# **100GBASE-CR4**

## **Comments D1.1 TBD's**

- **Comments to be submitted against 802.3bj Draft 1.1 cable assembly subclauses to replace TBD's with equations/values**

# Table 92-8-100GBASE-CR4 interference tolerance parameters

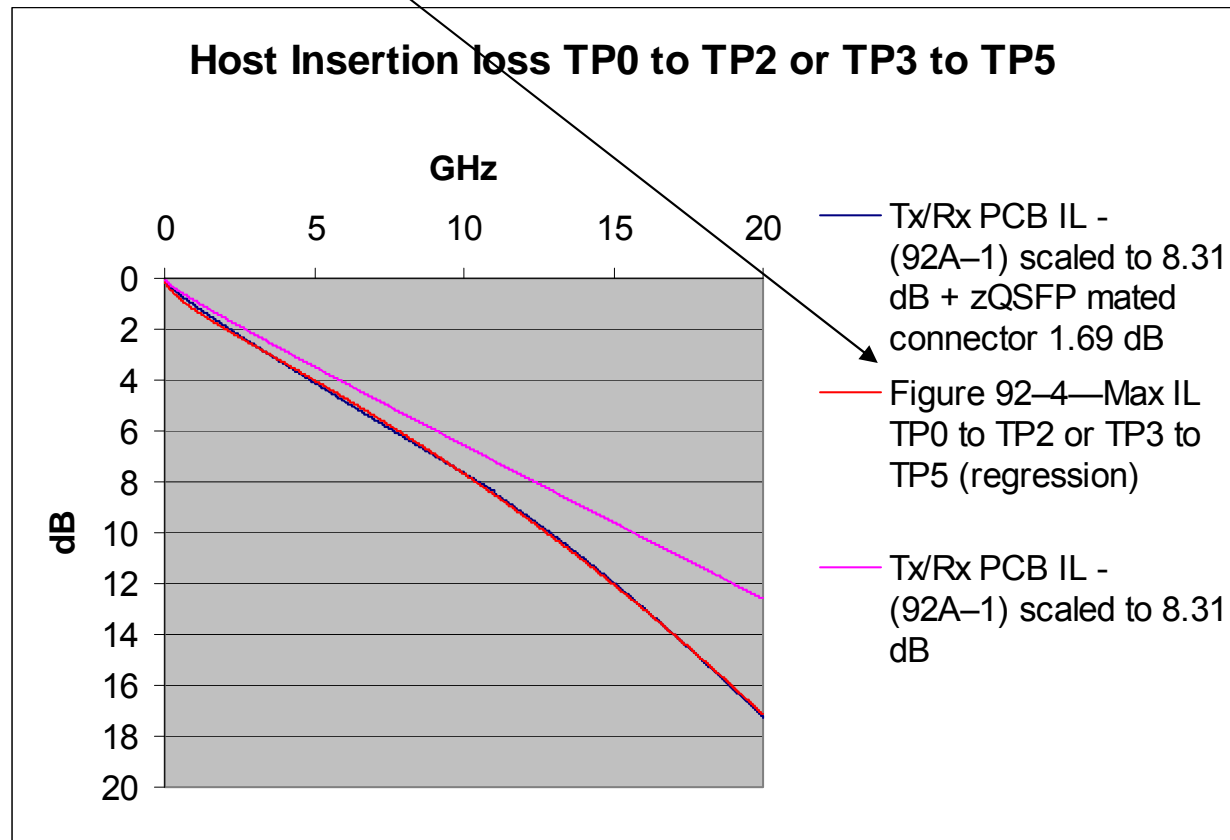
#275

**Test 1 IL consistent with = 0.5 m cable assembly + PCB IL**  
**Test 2 IL= 5.0 m cable assembly + PCB IL**

Parameter	Test 1 values	Test 2 values	Units
Maximum BER	$10^{-12}$	$10^{-12}$	
Fitted insertion loss coefficients	$a_1 = 1.7$ $a_2 = 0.546$ $a_4 = 0.01$	$a_1 = 4.3$ $a_2 = 0.571$ $a_4 = 0.04$	dB/ $\sqrt{\text{GHz}}$ dB/GHz dB/GHz <sup>2</sup>
Applied SJ <sup>a</sup> (peak-to-peak)	0.115	0.115	UI
Applied RJ <sup>b</sup> (peak-to-peak)	0.13	0.13	UI
Applied DCD (peak-to-peak)	0.035	0.035	UI
Calibrated far-end crosstalk (RMS)	6.3	2.2	mV
Calibrated ICN (RMS) – $\sigma_{nx}$	3.7	3.7	mV

# #285 Cable Assembly ICN – 5 m – 24 AWG

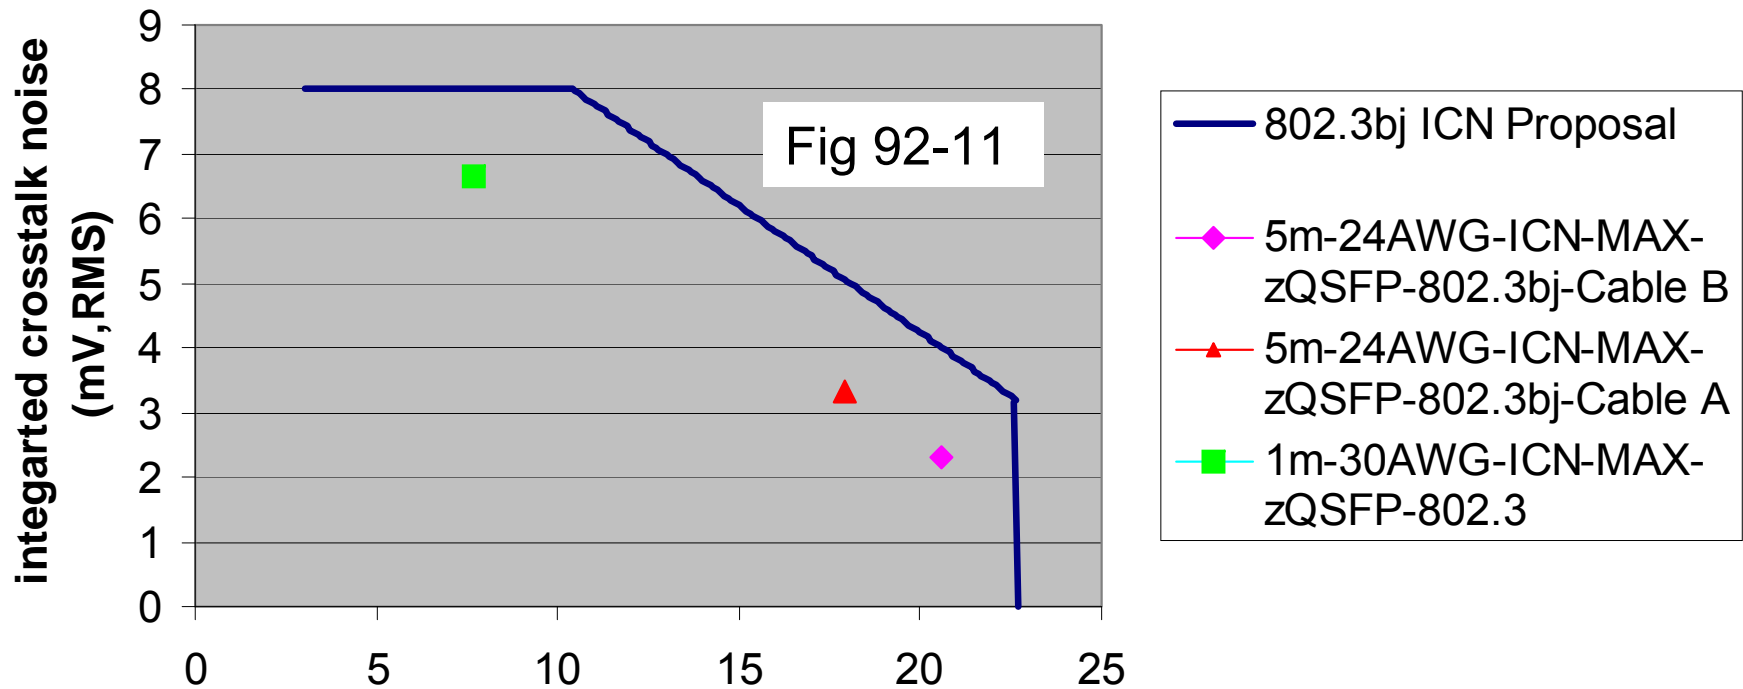
Proposal: Maximum integrated crosstalk noise for maximum cable assembly insertion loss of 22.64 dB at 12.89 GHz.	Revise Equation 85A-6	3.5 to 3.2	mV
--	-----------------------	------------	----

# 92.10.8 Cable assembly test fixture reference PCB IL

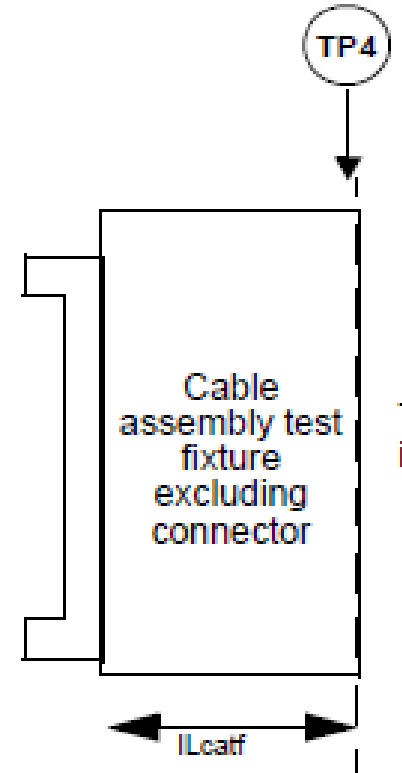
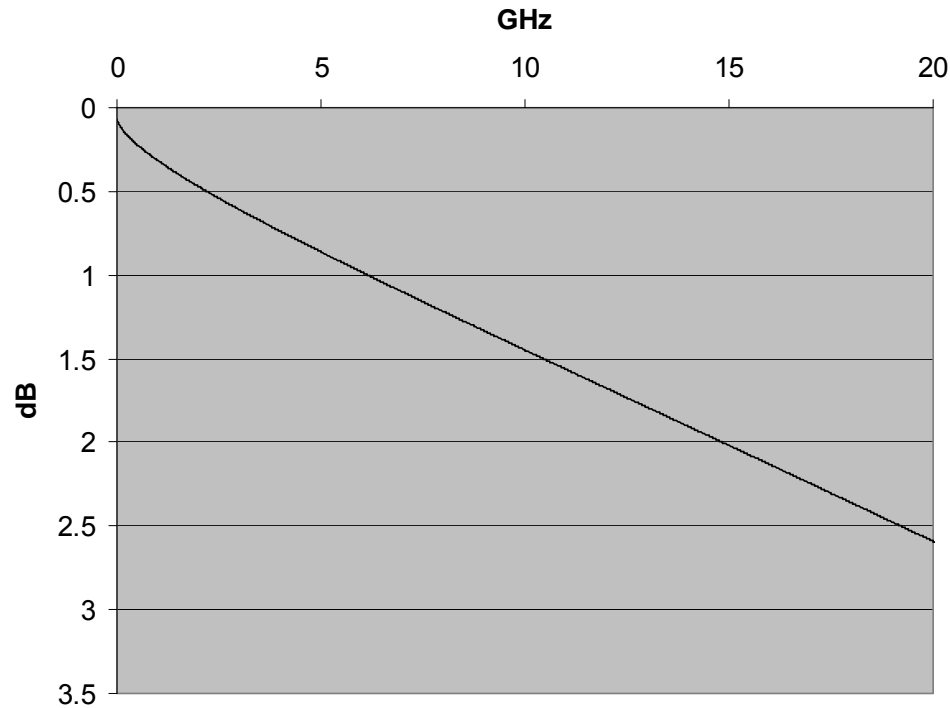
Cable assembly test fixture reference IL

$$L_{\text{catf}}(f) = 0.048 + 0.193 \cdot \sqrt{f} + 0.074f + 0.0005 \cdot f^2 \quad \text{dB}$$

# 92.10.9.1 Mated test fixtures insertion loss

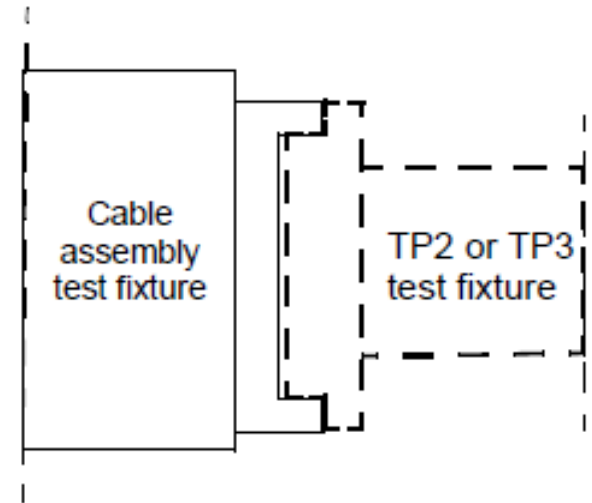
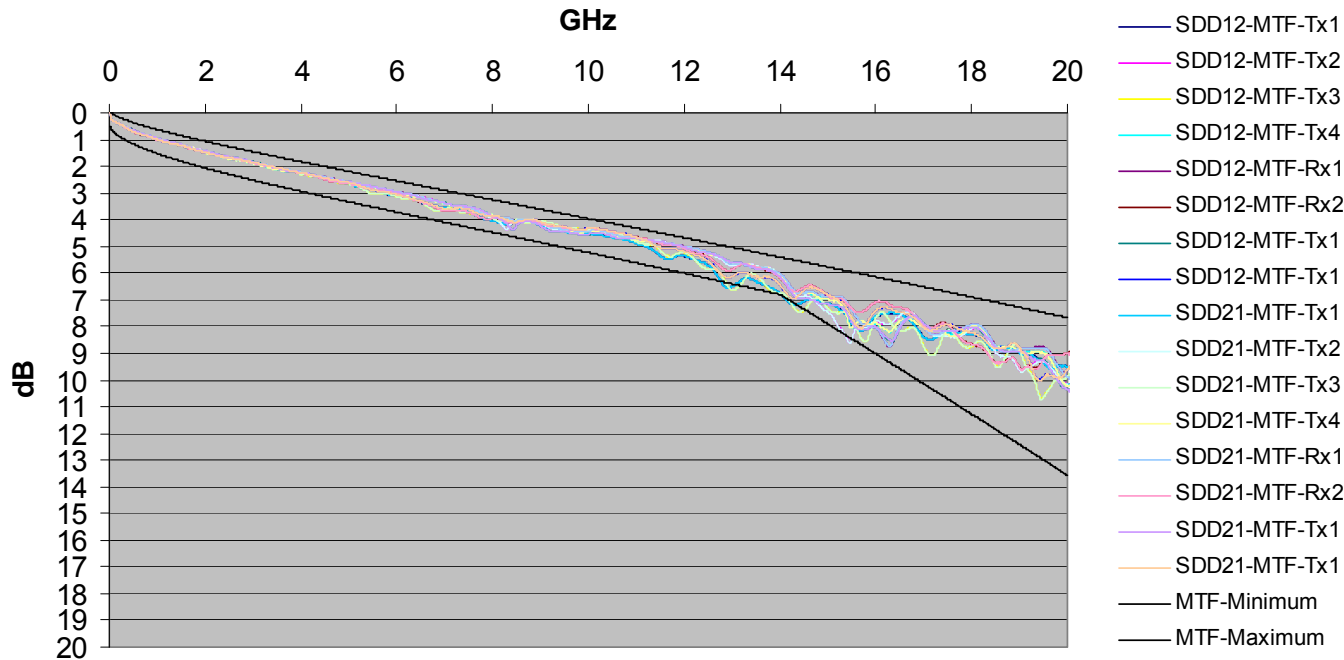
Mated Test Fixture Insertion Loss

Minimum  $IL_{MTFmin}(f) = -0.116 + 0.524*\sqrt{f} + 0.212*f + 0.003*f^2$  dB  $0.01 \leq f < 20$  GHz  
 $IL_{MTFmin}(12.89) = 5.00$  dB  $12.89$  GHz  
 $IL_{MTFmin}(14) = 5.40$  dB  $14$  GHz

Maximum  $IL_{MTFmax}(f) = 0.393 + 1.024*\sqrt{f} + 0.100f + 0.006*f^2$  dB  $0.01 \leq f < 14$  GHz  
 $IL_{MTFmax}(f) = -9.412 + 1.024*\sqrt{f} + 0.800f + 0.006*f^2$  dB  $14 \leq f \leq 20$  GHz  
 $IL_{MTFmax}(12.89) = 6.36$  dB  $12.89$  GHz  
 $IL_{MTFmax}(14) = 6.80$  dB  $14$  GHz

# 92.10.9.4 Mated test fixtures common-mode conversion loss

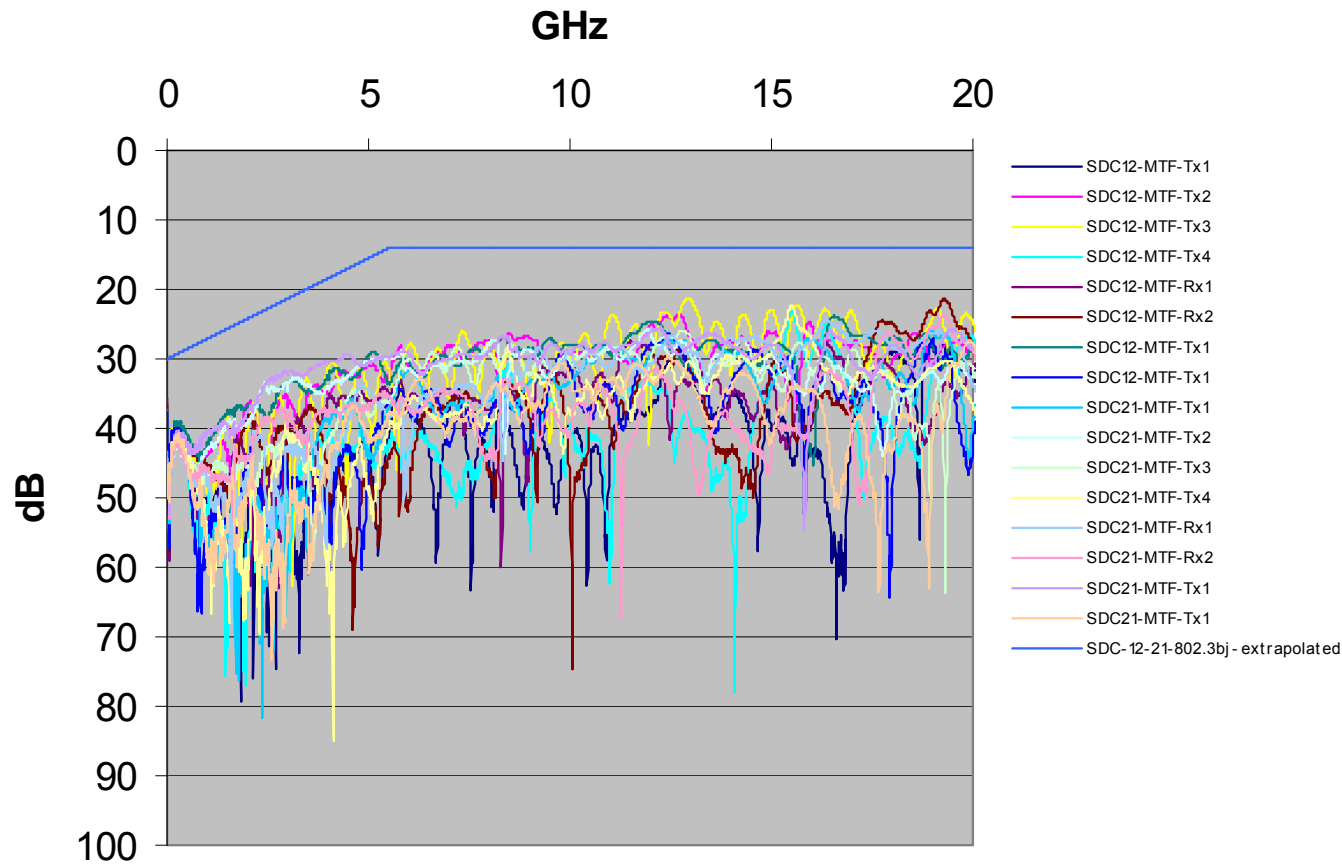
## Mated test fixture conversion loss

$$30 - 2.91 * f$$

14

$$0.01 \leq f < 5.5 \text{ GHz}$$

$$5.5 \leq f \leq 20 \text{ GHz}$$
